# Memorandum

TO: James Flockton  
FROM: Ella Harrison  
DATE: 28 March 2018  
SUBJECT: North Byron FRMS&P –Hydrologic and Hydraulic Model Review  
PROJECT NUMBER: 117098

**Figure 1: Hydrologic and Hydraulic Model Boundaries**

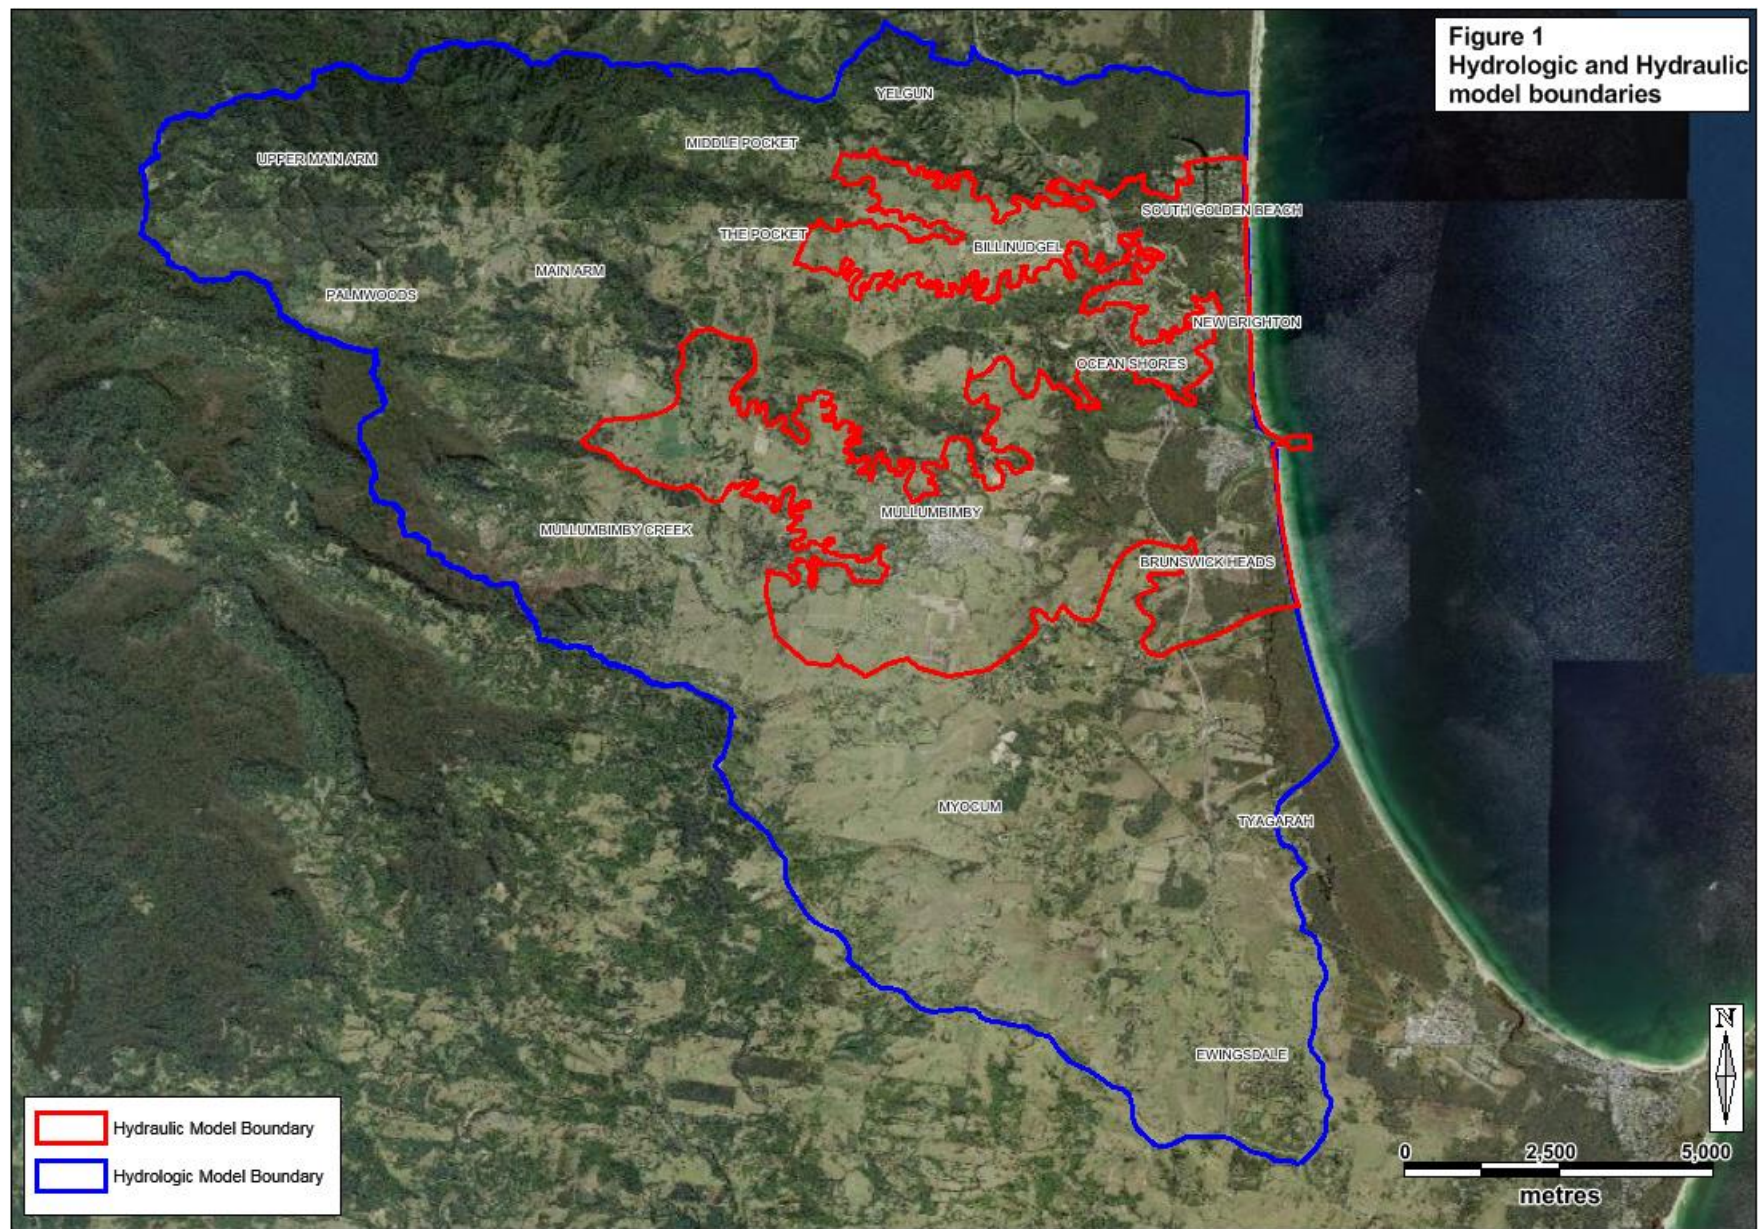
Figure 1 shows the hydrologic and hydraulic boundaries used within the Flood Study.

**Figure 2: Sub-catchments division**

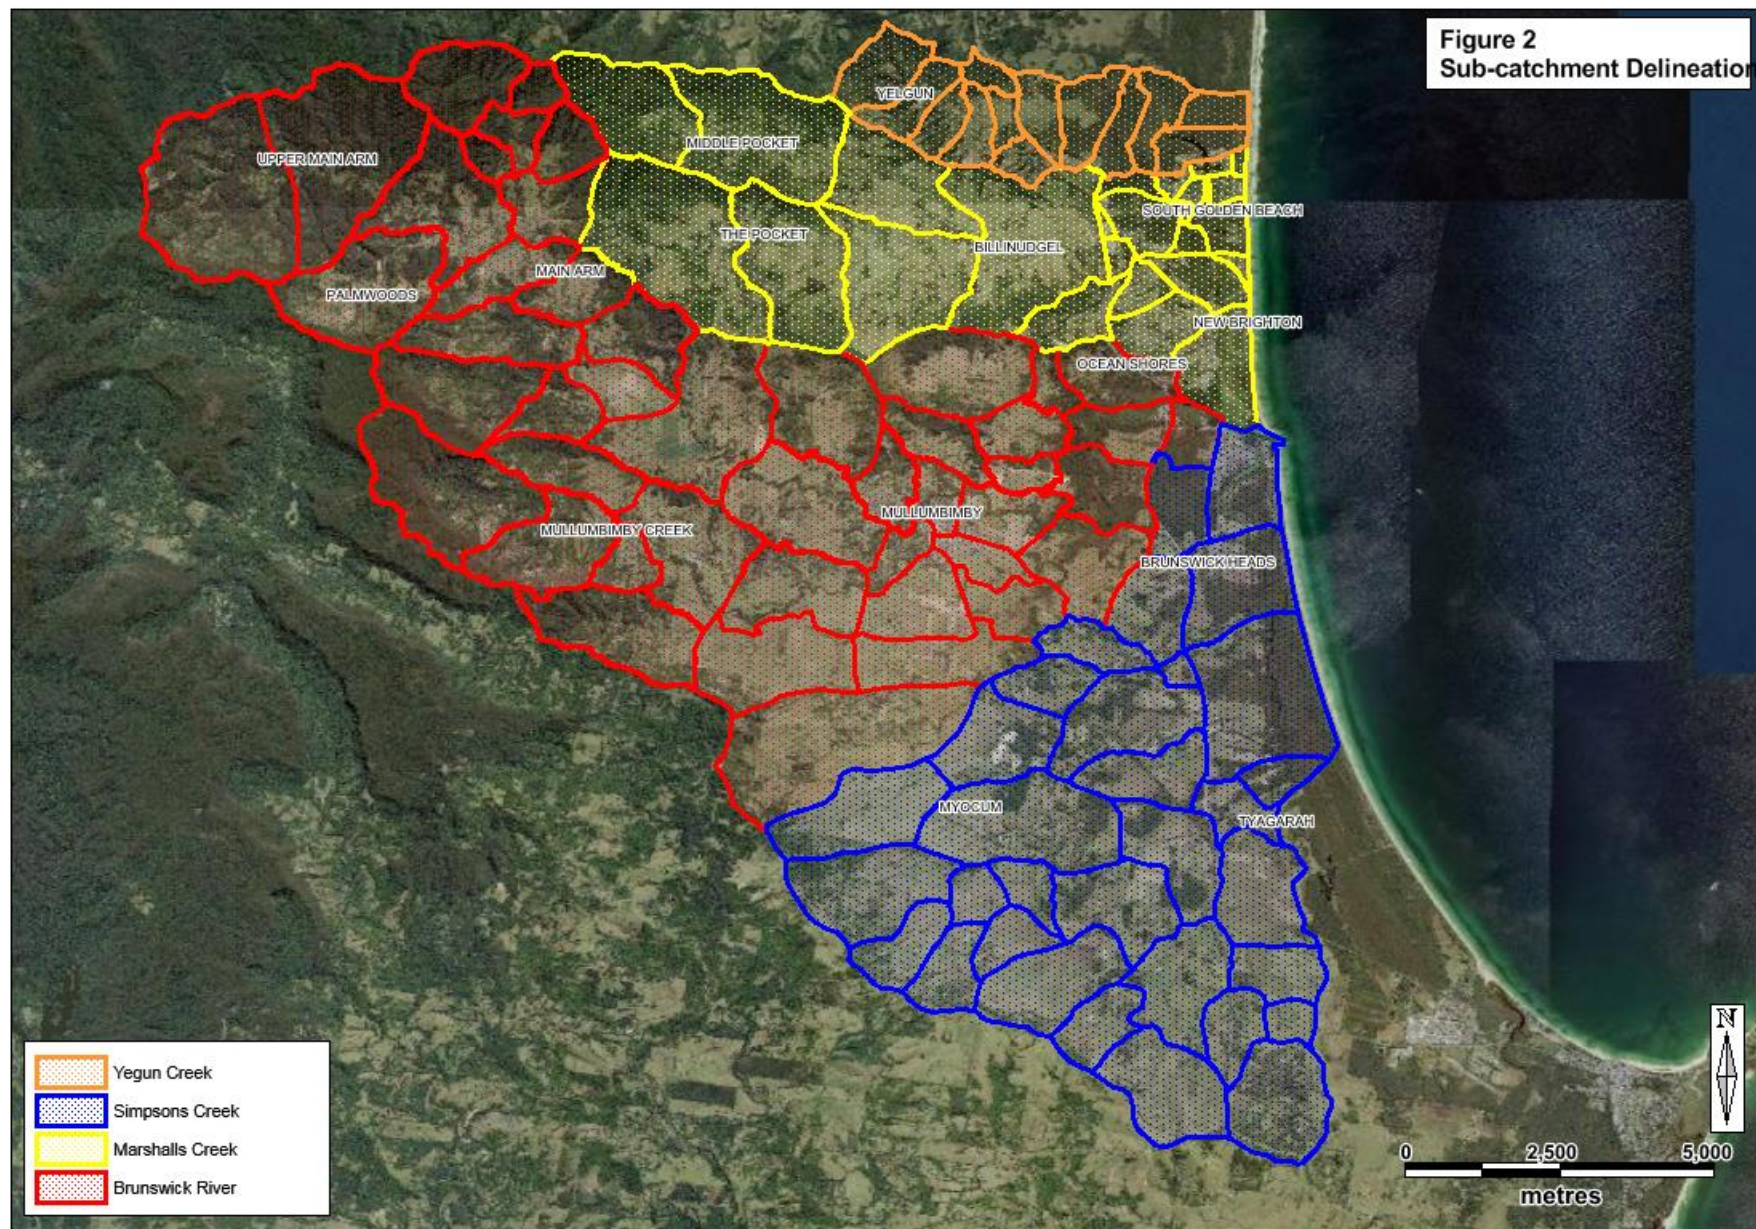
The hydrologic study area consists of four catchments and are listed in Table 1. The delineation of the catchment and sub-catchment boundaries has been checked and is considered fit-for-purpose and appropriately defined. The sub catchment delineation is shown in Figure 2.

**Figure 4: 2D Domain Grid Size**

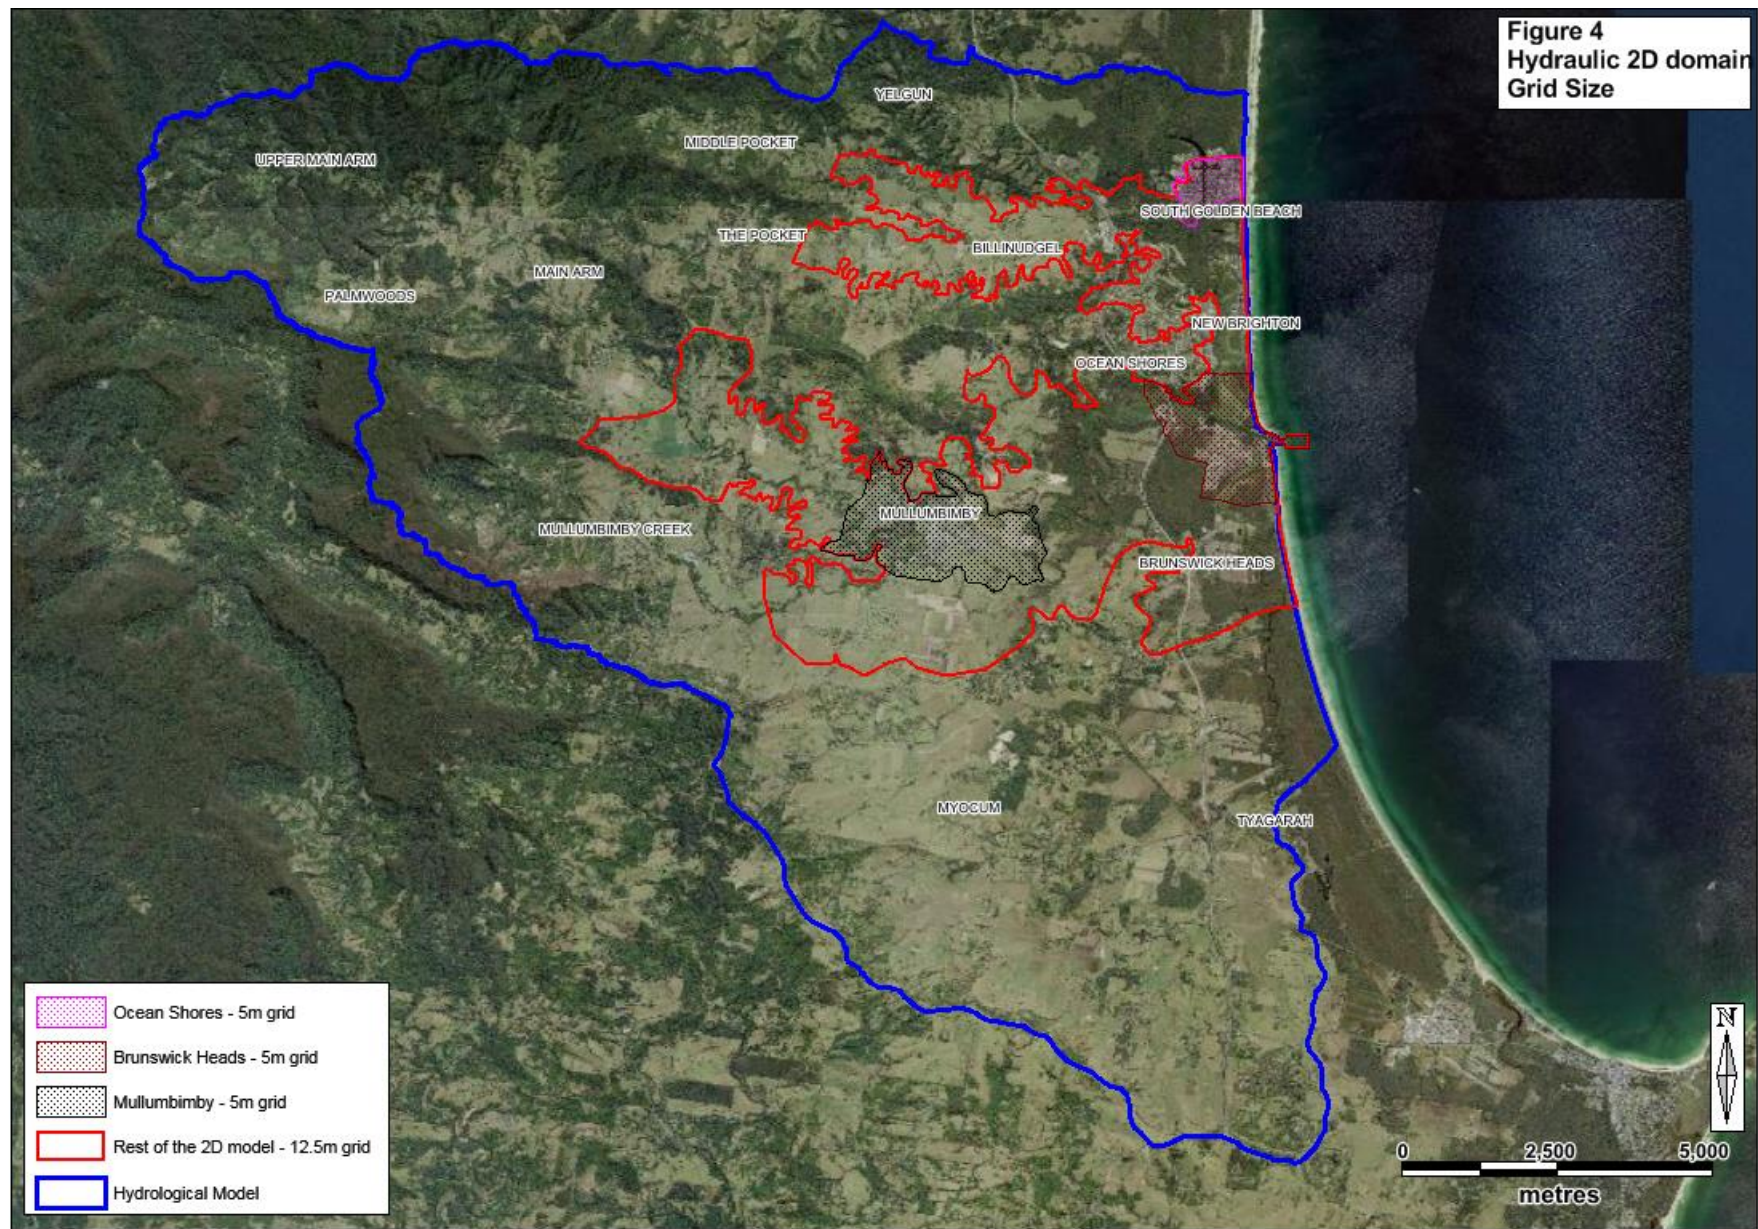
Figure 4 shows the hydraulic model boundary and the domain configurations. The hydraulic model covers 52 km<sup>2</sup> in total. The default 2D domain was represented with a 12.5m grid with a north-south grid orientation. For the areas of South Golden Beach and Brunswick Heads a 5m grid with no rotation was adopted. Mullumbimby was also represented using a 5m grid size, however a 19.5 degree grid rotation was applied. This rotation digitises the grid perpendicular to the dominant flow and is handled properly by TUFLOW.

Marshall's Creek, Brunswick River and Simpson's Creek are modelled in 1D by cross sections when the 2D domain grid size is set to 12.5m (see Figure 4).

Figure 5: Boundary Conditions

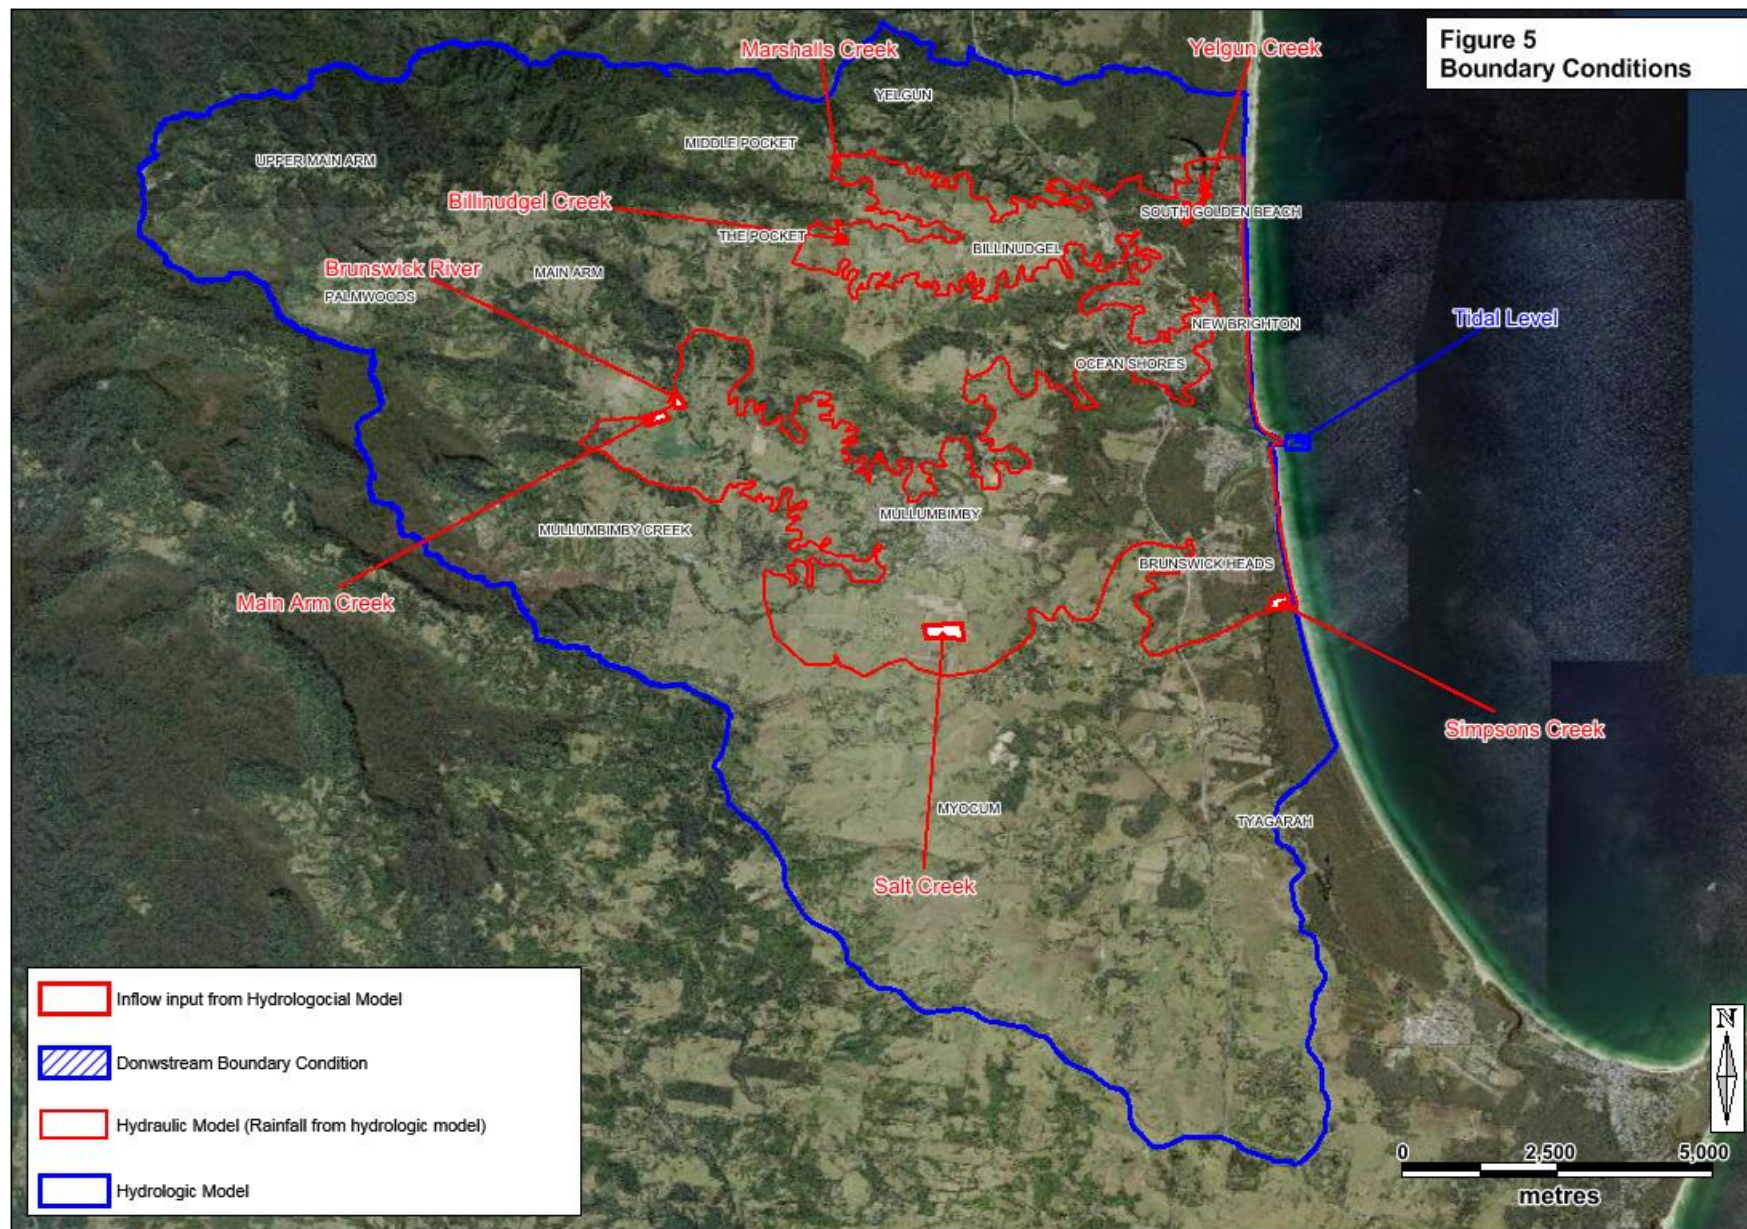
Figure 5 shows the inflow and downstream boundaries included in the Flood Study model. The downstream boundary has been setup up as a water level versus time boundary to represent the tidal conditions. This tidal condition is variable and the timing of the peak of the tide has been aligned to coincide with the peak of the flood. Table 5 describes the corresponding peak tidal conditions for each AEP and climate change conditions. Byron Shire Councils policy on Climate Change Strategic Planning discusses the adopted 2050 and 2100 and are 0.4m and 0.9m respectively.

Figure 6: Ground and Terrain Data

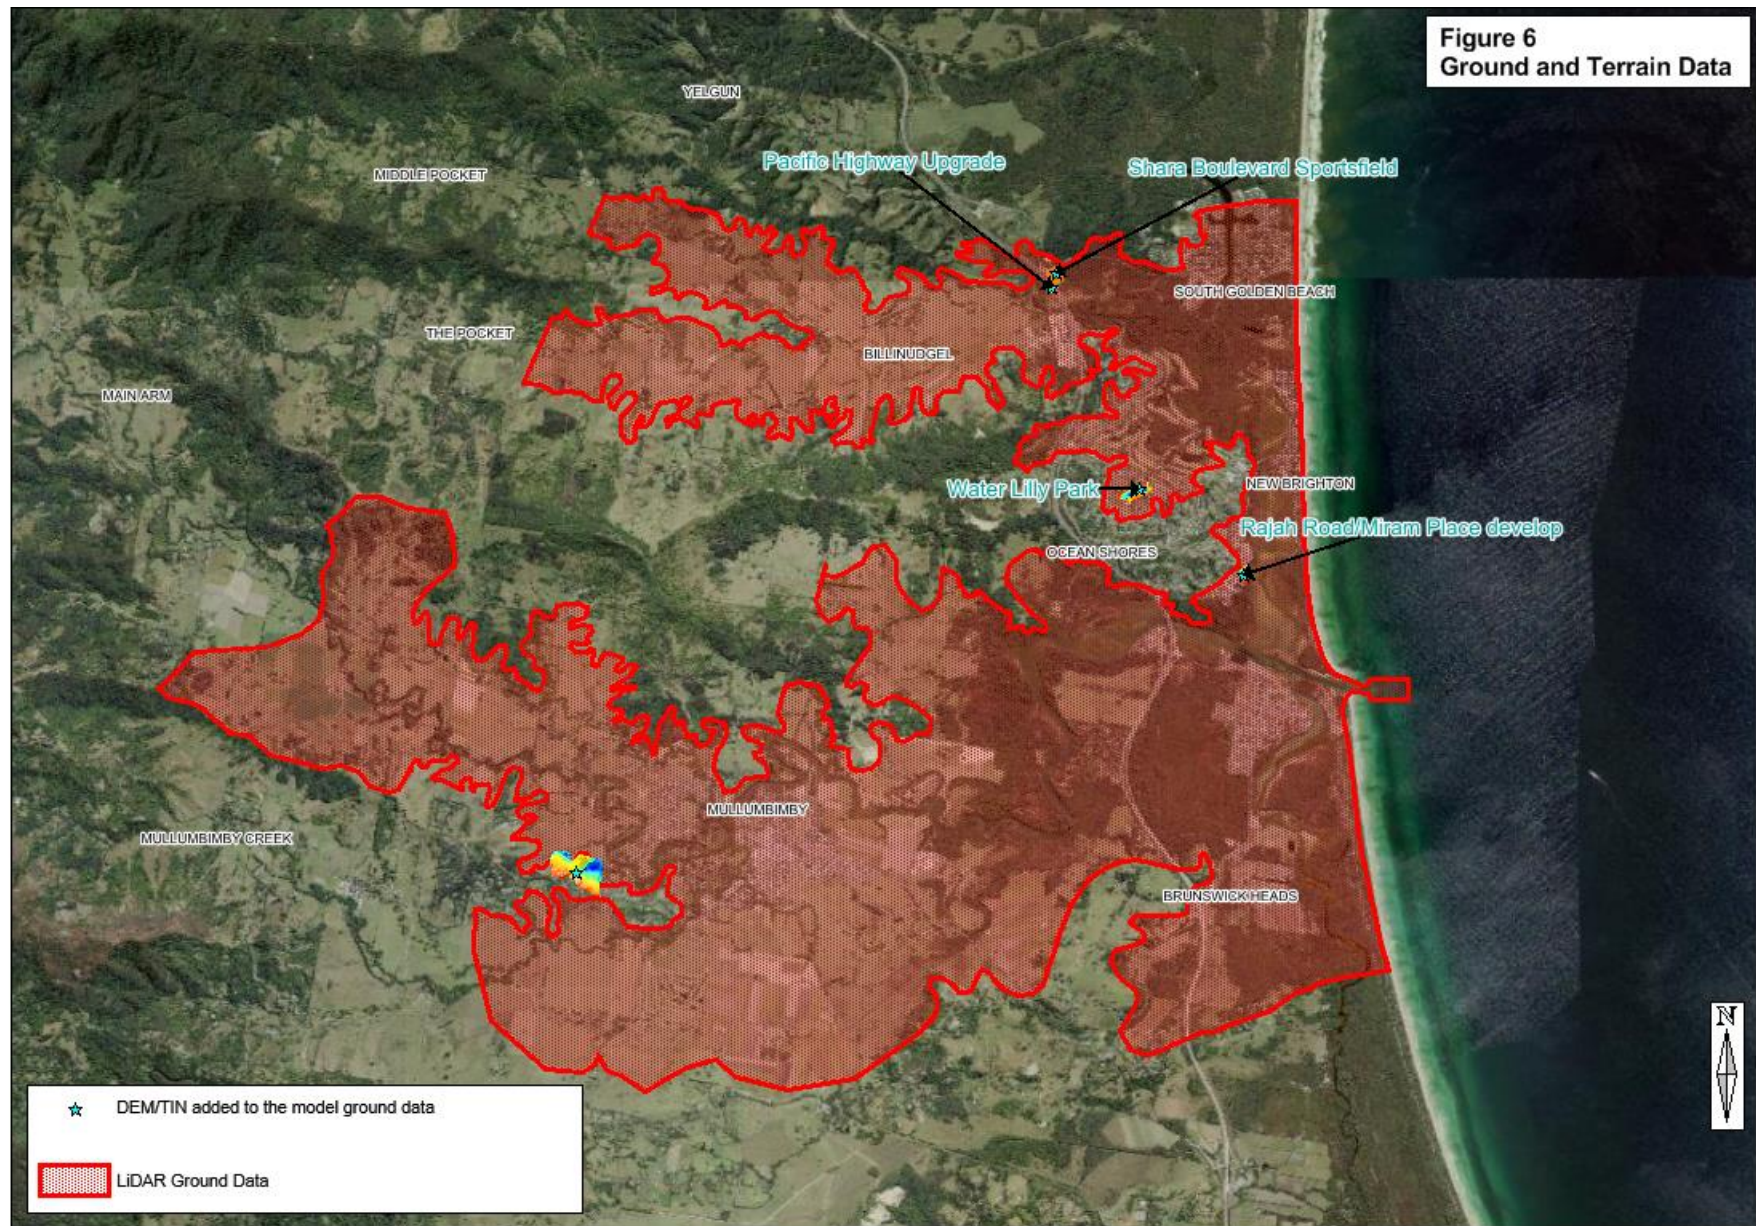
Figure 6 shows the ground and terrain data used in the hydraulic model.

Orchid Place roughness is defined as an urban place. The recent development topography has not been included in the model.

The roughness need to be updated to match the new development (from  $n = 0.045$  to  $n = 0.025$ ). Byron Shire Council has sent the latest development drawings to WMA Water and it is recommended these added to the model topography.

The model includes the Stage 3 development terrain data. Byron Shire Council has sent the Stage 4 development drawings to WMA Water including the Tuckeroo Avenue box culvert dimensions. It is recommended the model is updated to incorporate this information.

The model includes an older development terrain data. Byron Shire Council has sent the Stage 4 development drawings for Miram Place in Ocean Shores to WMA Water. It is recommended this information is incorporated into the model.

It is recommended this information is incorporated into the model. Byron Shire Council will request and provide a survey of the area.
